RFI #Constr-412: CS - Deletion of Bulletin 2 Roof Duct Enclosure Under Dunnage

RFI #Constr-313: CS - Roof Ductwork and Dunnage Coordination

Subject: Roof Ductwork vs Dunnage
Discipline: Sheet Metal
Specification Section: 2331000
Drawing No: M1.00-CS, M1.11-CS

CMP Tower A RFI#Constr-412

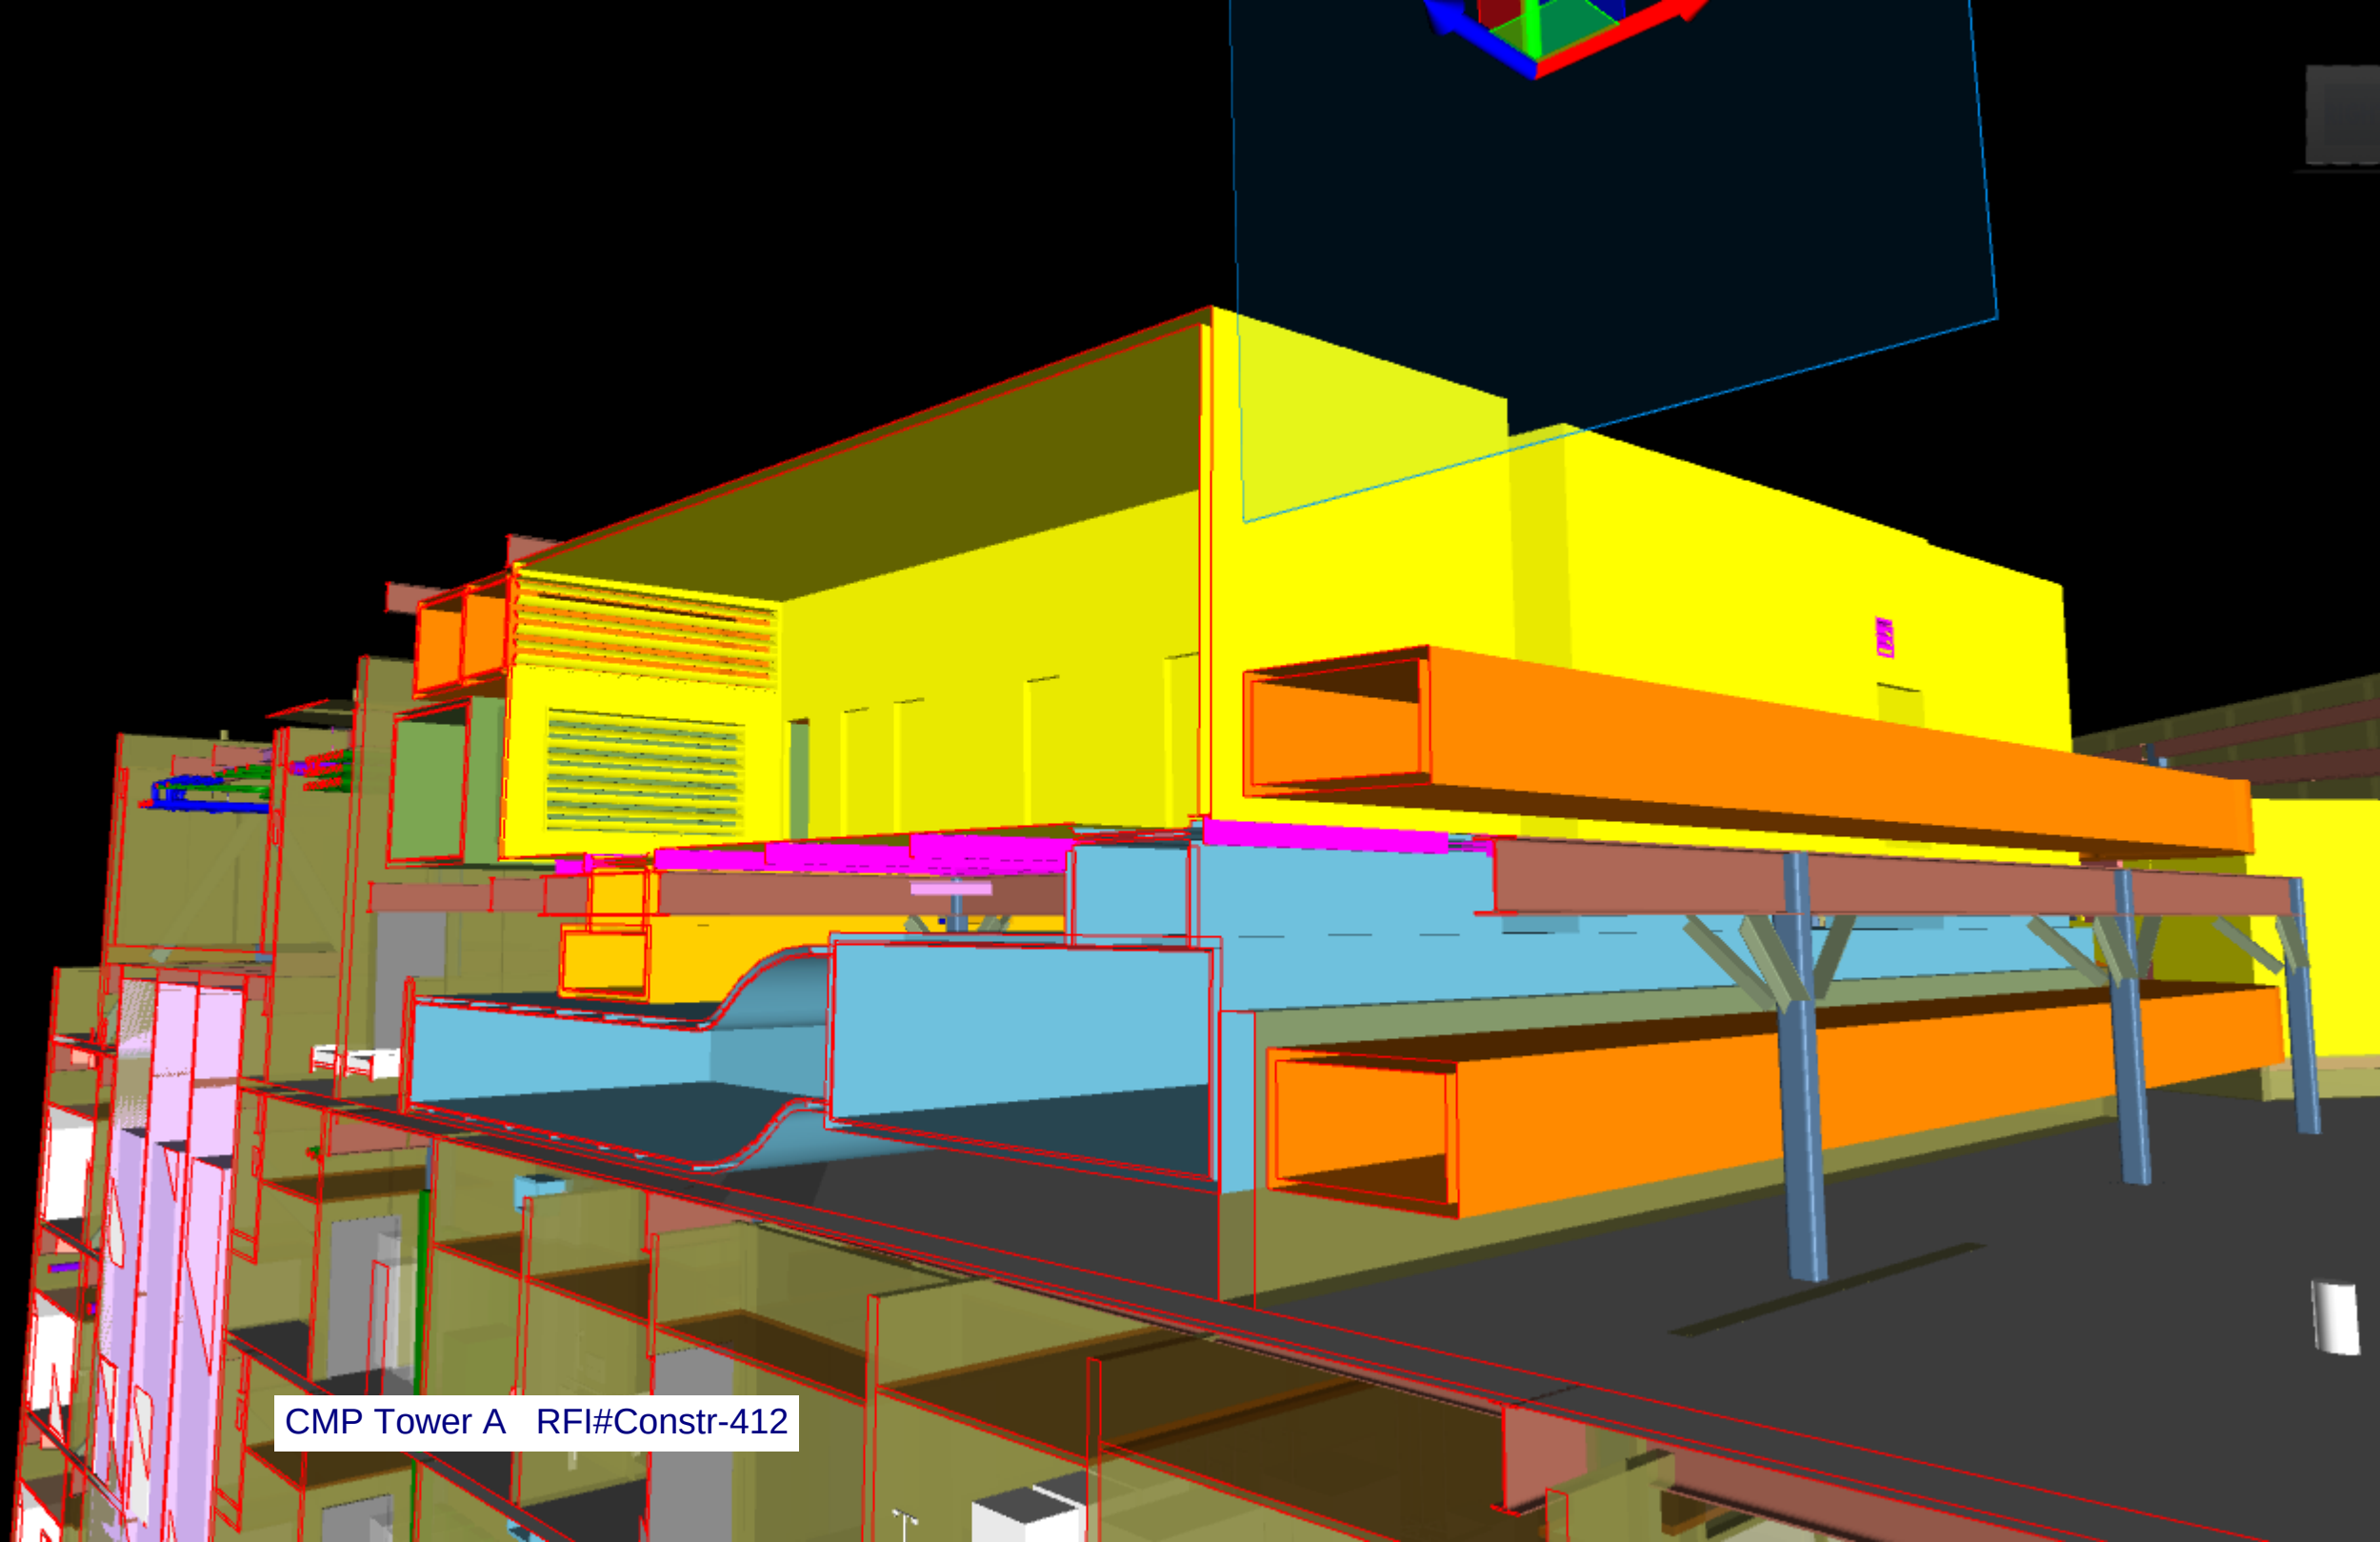
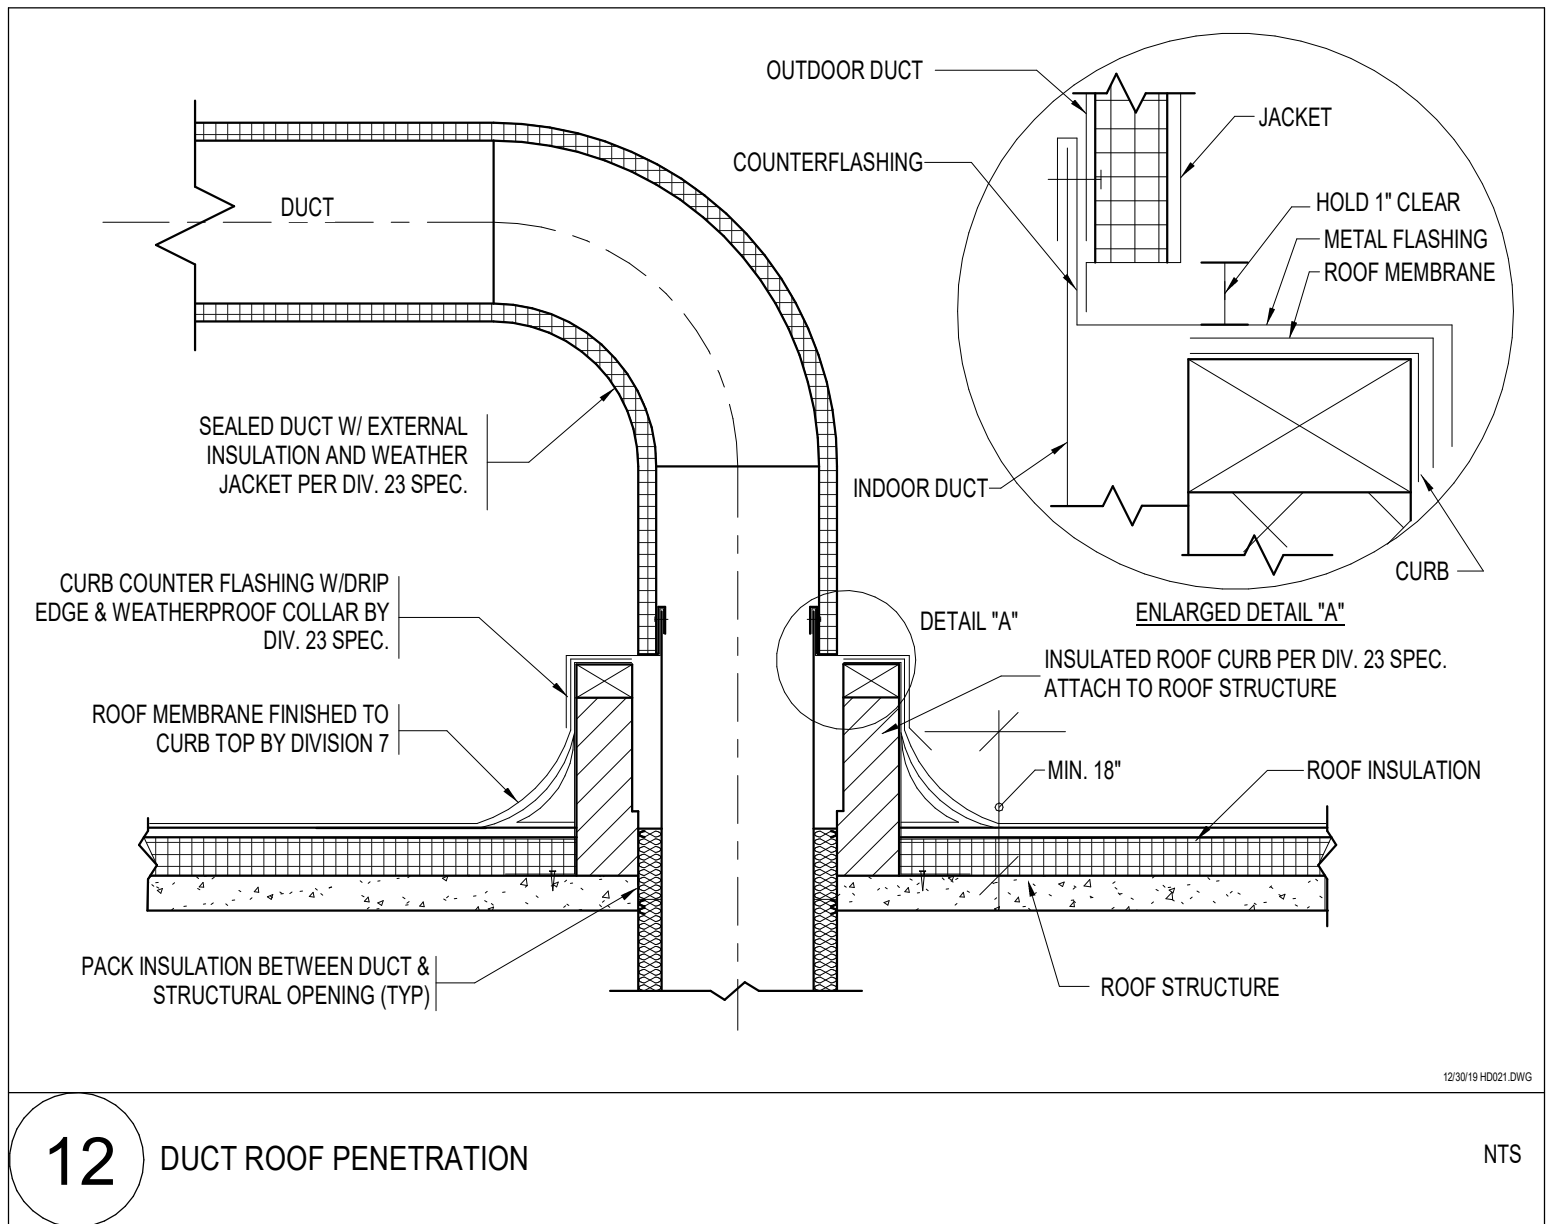
After review on Bulletin 2 costs to add roof duct enclosure under dunnage per A1.111, 7/A6.33, and 18/A7.04 it was determined that costs were no acceptable. Response to RFI #Constr-313 raised the dunnage 3'-0" to alleviate need for roof duct enclosure. However BR&A required cost evaluation between the two. See attached ROM pricing for ductwork and structural steel of approx. 40K.

Provide revised Architectural drawings A1.111, A6.33, and A7.04 to delete roof duct enclosure under dunnage.

Raise dunnage and associated HVAC units and ductwork in it's entirety 2'-9". Eliminate ductwork enclosure and extend roofing accordingly. Add additional risers and treads to dunnage access stairs. See attached revisions.
- HT/HKS
